Memorandum 4

Fast Track Application FTAA-2507-1087: Ashbourne Development, Matamata

Minute 3 of the Expert Panel dated 21 November 2025 - Response to Request for Information on behalf of Matamata-Piako District Council (stormwater/ erosion and sediment control)

The design criteria stated within the Greenway memo provided by Maven dated 23rd September 2025:

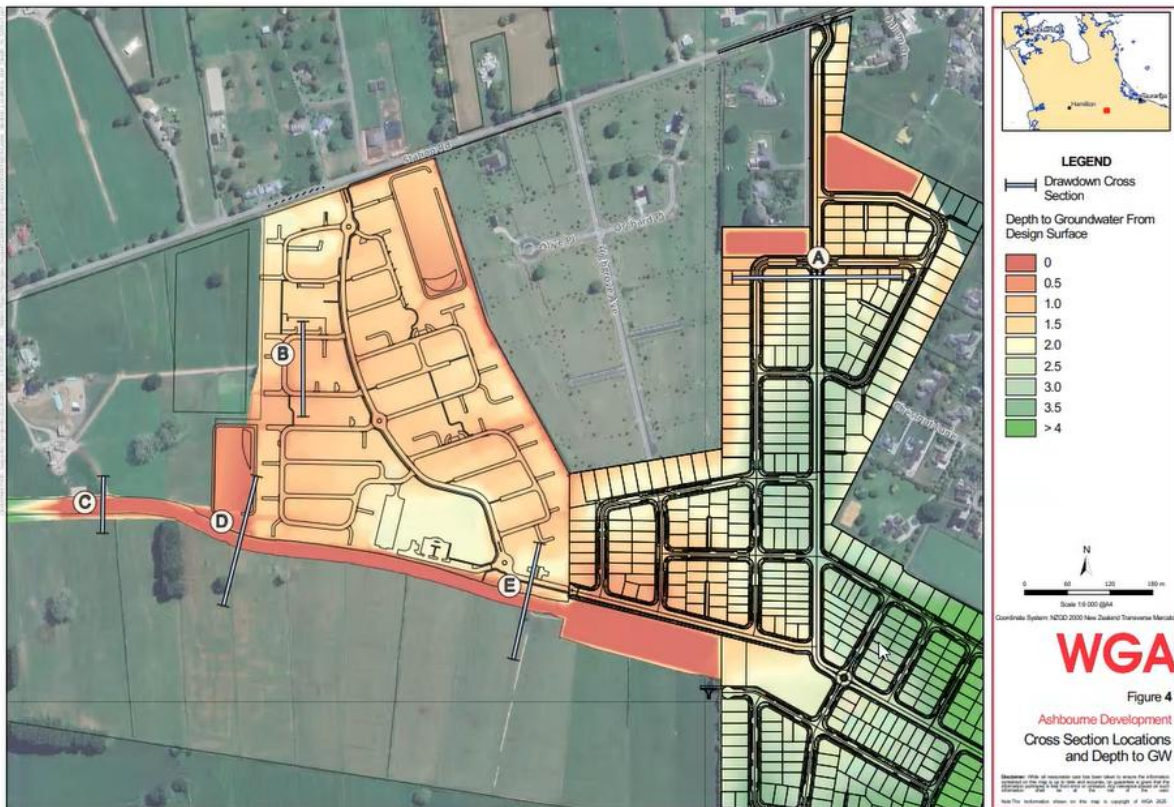
To respond specifically to the expert panel Minute 3 request, the following is noted:

The attenuation to 80% predevelopment is limited to the 100yr rainfall event only, other rainfall events have not been assessed as to the effect on the receiving environment in particular the Waitoa Stream.

Given that the WGA hydrogeological report (dated 18th November) highlighted the groundwater interaction with the Greenway, I recommend further assessment is to be

undertaken as to the attenuation requirements for the discharge to the Waitoa River and the effect of this discharge.

Regarding Greenway discharge erosion effects, an assessment should be carried out for rainfall events ranging from frequent to large occurrences. The current substantive application does not provide enough information to comment on how frequent rainfall events affect the discharge from the Greenway to the Waitoa River. For larger rainfall events, additional assessment is required, as discussed in the preceding paragraphs.
